Lavender Fashion Ltd (Unit-01)

8 February 2026

Structural Inspection Report

Observation 1: Inconsistencies in the design report and load plan. (Production Building)

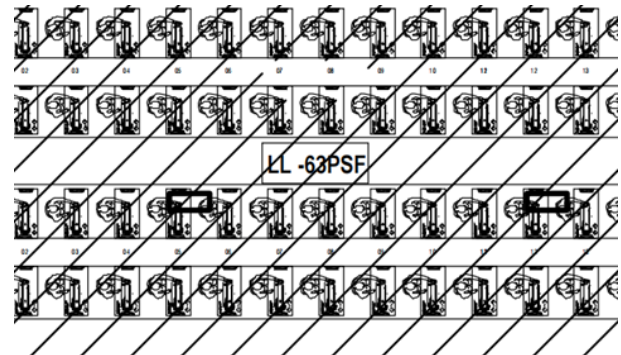
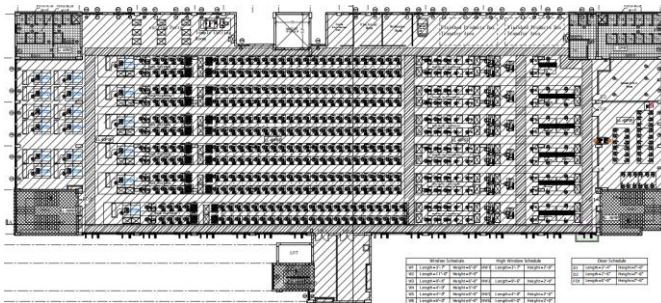
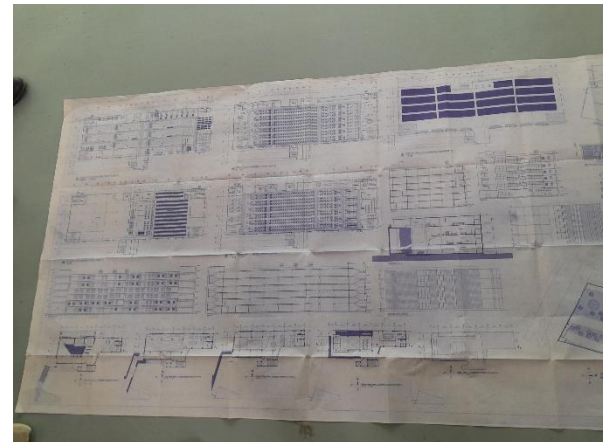
Description: Permit drawing was approved after February 2021. The design documents were prepared for the building considering BNBC-06 and design live load was considered as 3.0 kPa for the production area. However, as per the BNBC 2020, the required live load for a "garments manufacturing floor" is 4.0 kPa.

The building engineer is required to revise the load plan in compliance with BNBC 2020, update the design report according to BNBC 2020 and submit the complete set of documents, including the lift core and roof top shed to RSC for review.

Item No.	Observation	Action Plan	Timeline
1.	Inconsistencies in the design report and load plan. (Production Building)	The factory engineer is required to revise the load plan as per the BNBC 2020 requirement and check the design accordingly.	within 6 weeks

2.		The building engineer is required to submit the updated design documents, including the lift core and roof top shed.	within 6 weeks
3.		Carryout suggested remedial works (if required).	within 6 months

Observation-2: Mismatch in as-built drawing and no credible structural construction drawing (Production Building).

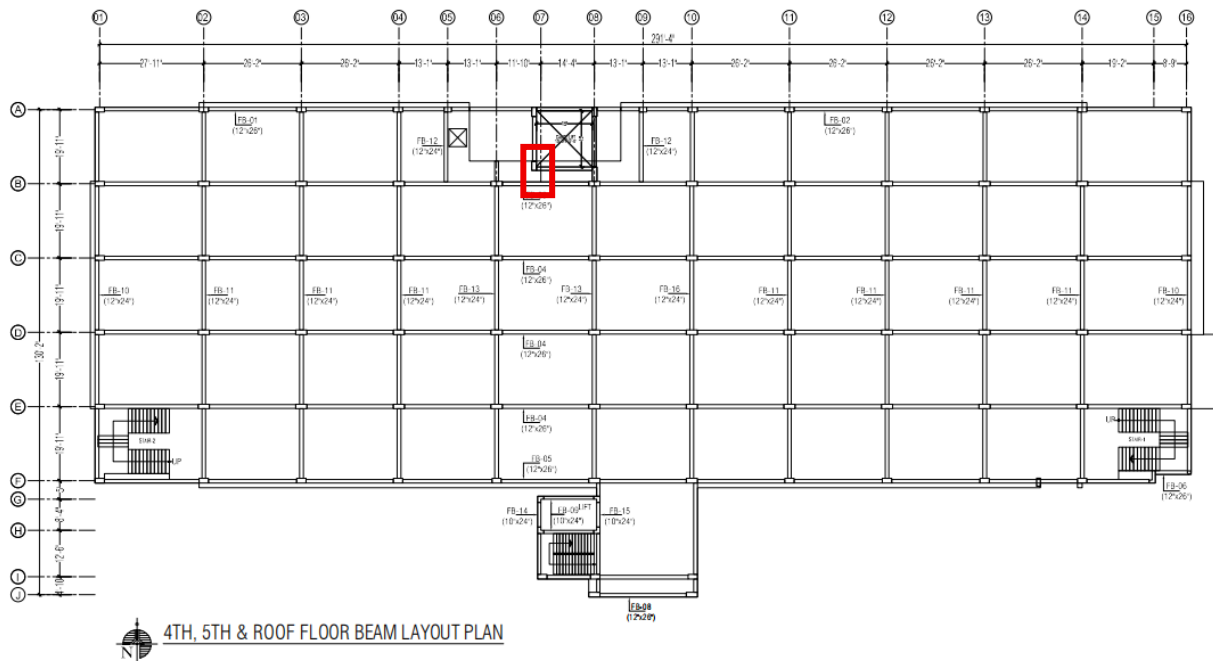
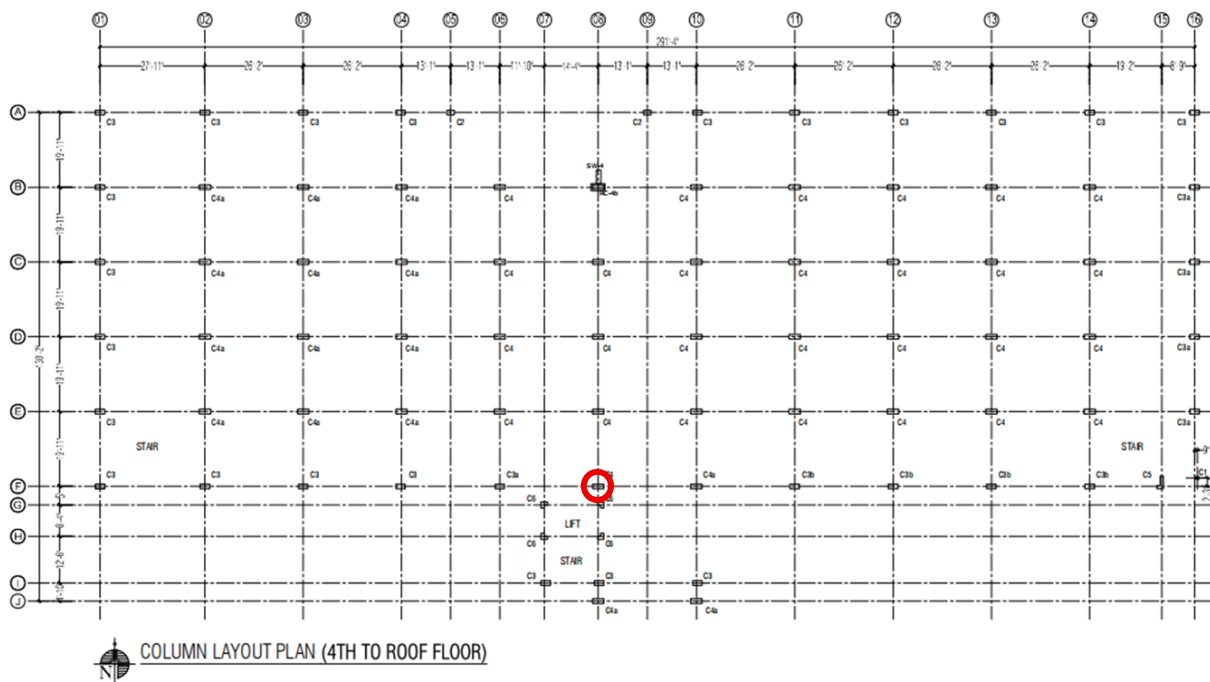
RC Beam found connected with main structure in this location on all floors not shown in drawing

Marked RC column size was found 375X750 mm instead of 375X900 mm

Description: During inspection, mismatch was found in between as-built drawing and onsite condition of Production Building. Also, no credible structural construction drawing was found to verify the foundation information. Factory engineer is required to verify foundation information and prepare accurate as-built drawings.

4.	Mismatch in as-built drawing and no credible structural construction drawing (Production Building).	Factory engineer is required to verify foundation information and prepare accurate as-built drawings.	within 6 weeks
